## Addendum #1

**Brewer Armory Telecom (IT) Room Repair Project - Project No: 23SR19-310-D4, Bid Number #23-029**

Directorate of Facilities Engineering

28 August 2023

SHEET ID:  
**C-101**  
 SHEET: 3 OF 18

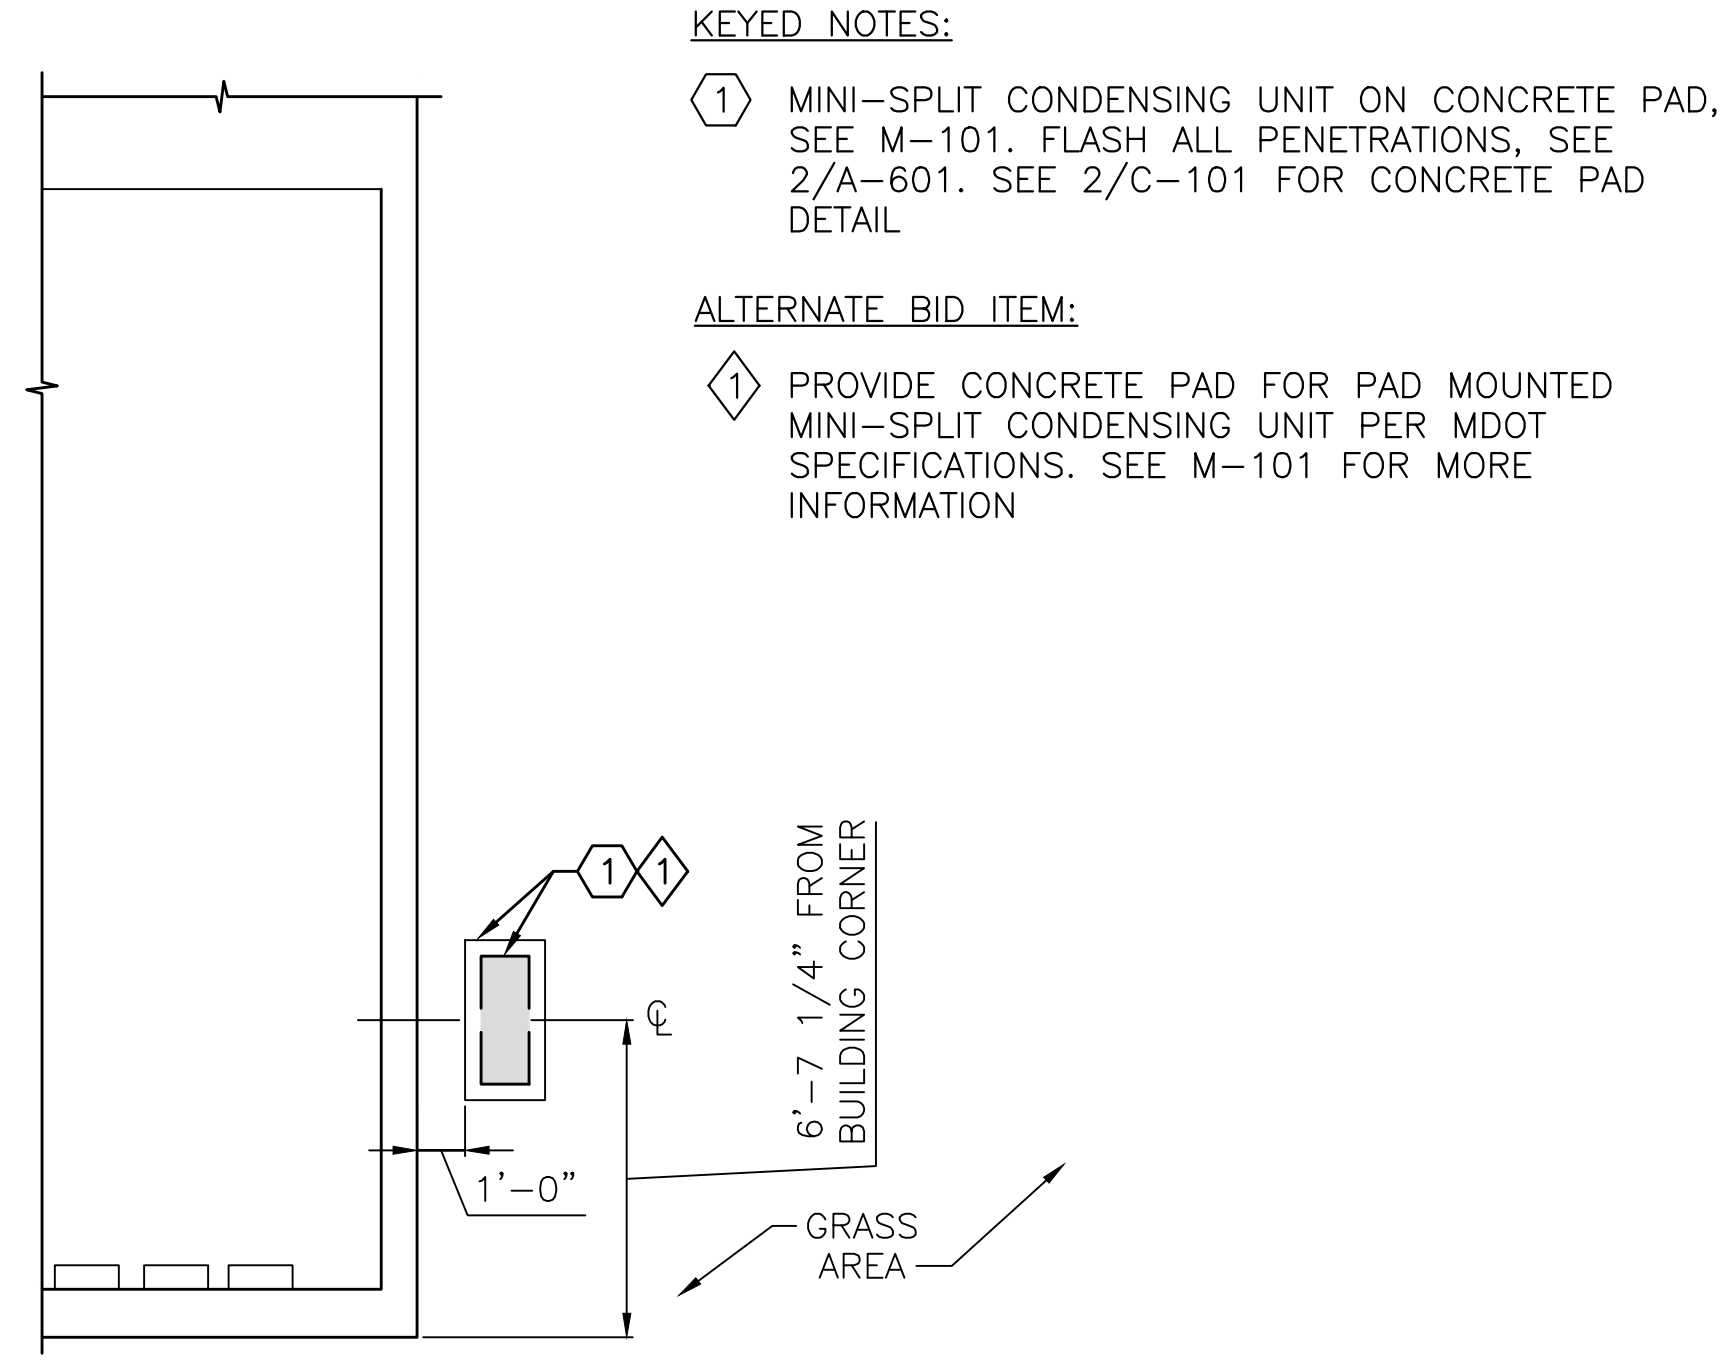
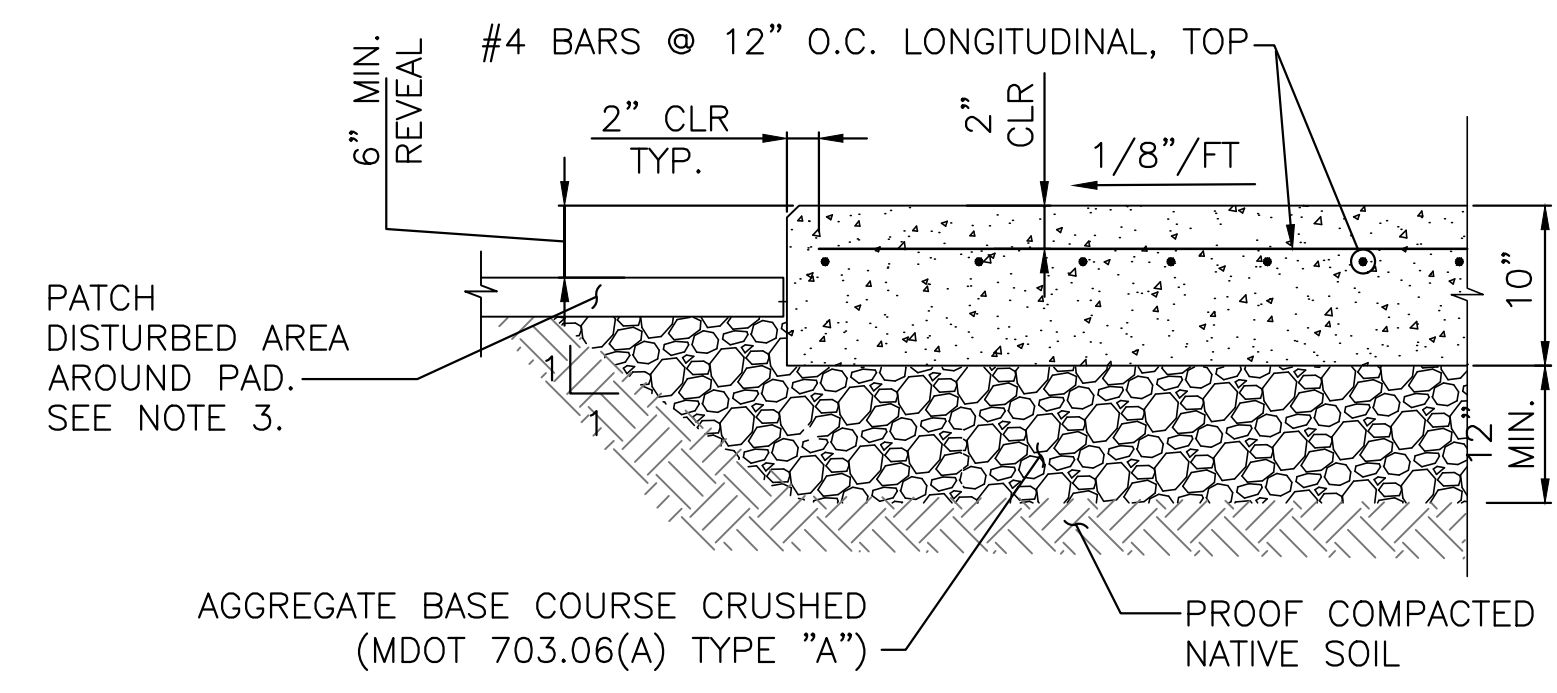
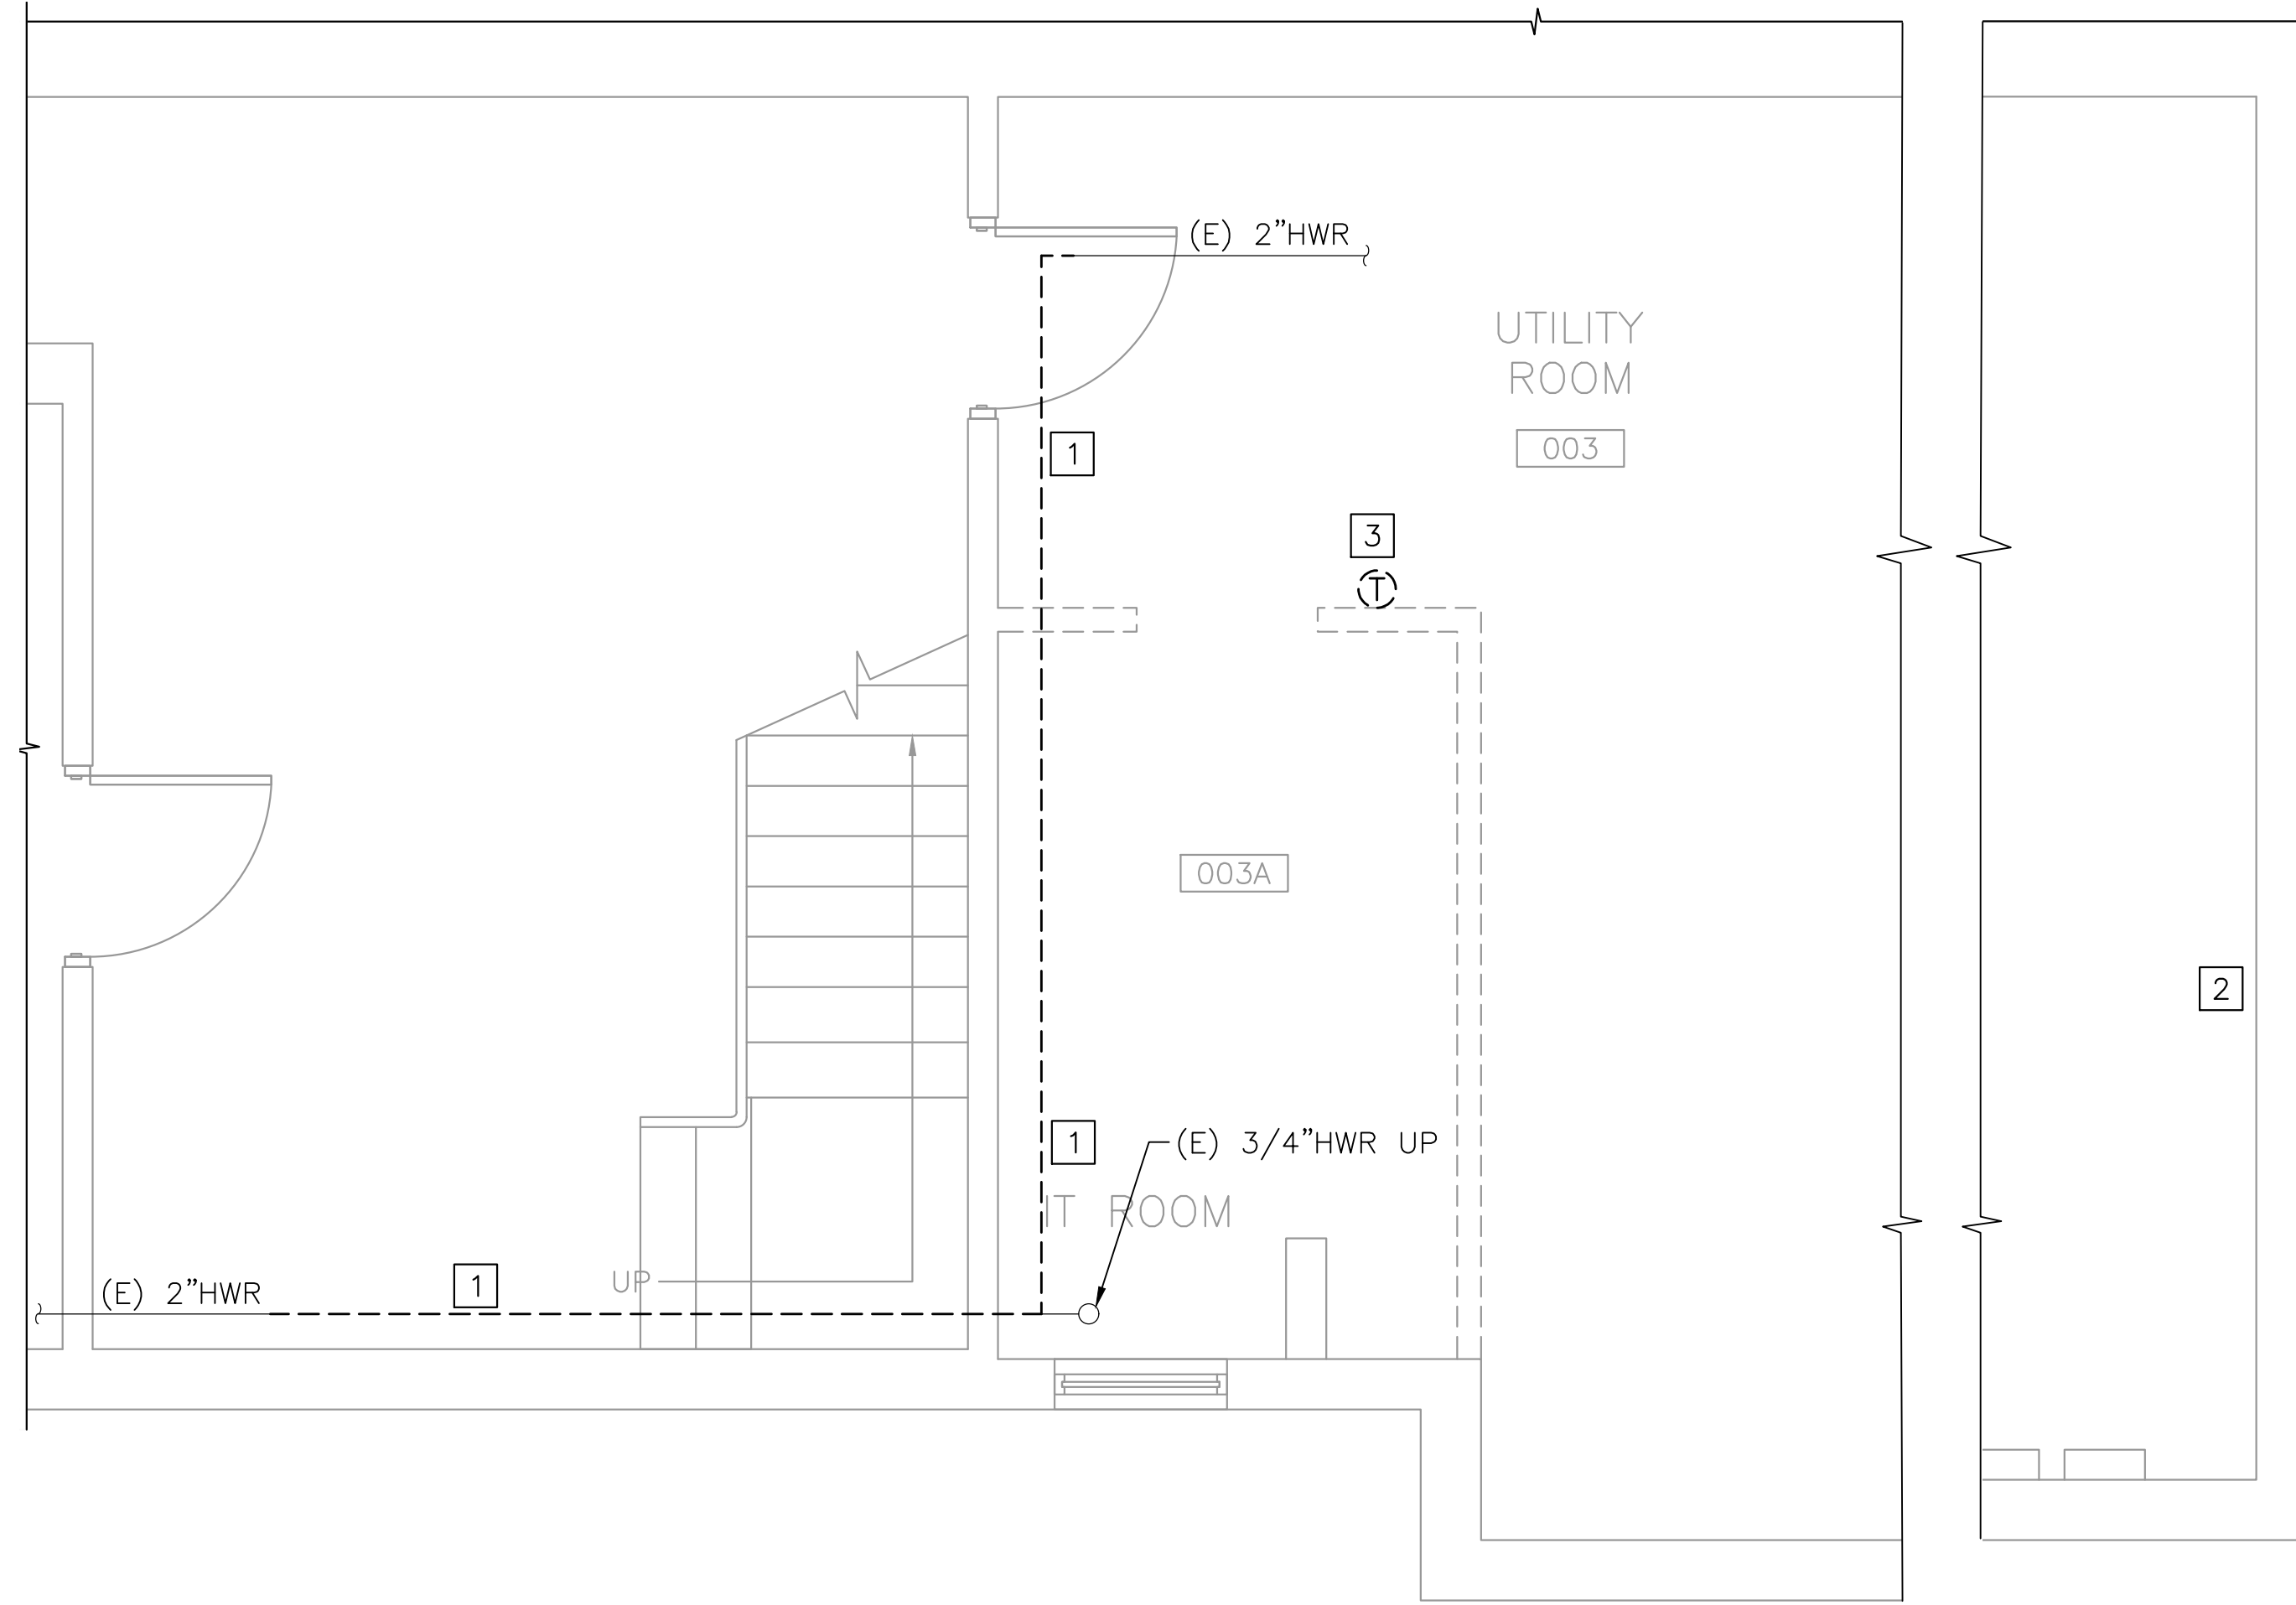
1. **Remove** Sheets C-101, M101 and M-501 and **Insert** attached Sheets C-101, M101 and M-501. All changes regard either the attachment of the mini-split condensate unit to the facility or its placement on a concrete pad immediately adjacent to the facility (ABI#1)

An ABI has also been added to the design plans. ABI scope is to provide a concrete pad to mount the unit on if that turns out to be the Historical Society's determination.

① **ABI#1 CONCRETE PAD MOUNTED UNIT**  
 C-101 SCALE: 1/4" = 1'-0" A-101

- NOTES:**
- CONCRETE MUST BE 4,500 PSI WITH 6% AIR ENTRAINMENT
  - PROVIDE A BROOM FINISH, AND 3/4" CHAMFERED EDGES
  - DISTURBED AREA PATCHING:
    - GRASSED AREAS MUST BE LEVELED WITH COMPACTED NATIVE SOIL AND RECEIVE A MIN OF 4" OF LOAM AND SEED.

② **TYPICAL CONCRETE PAD DETAIL**  
 C-101 SCALE: NTS
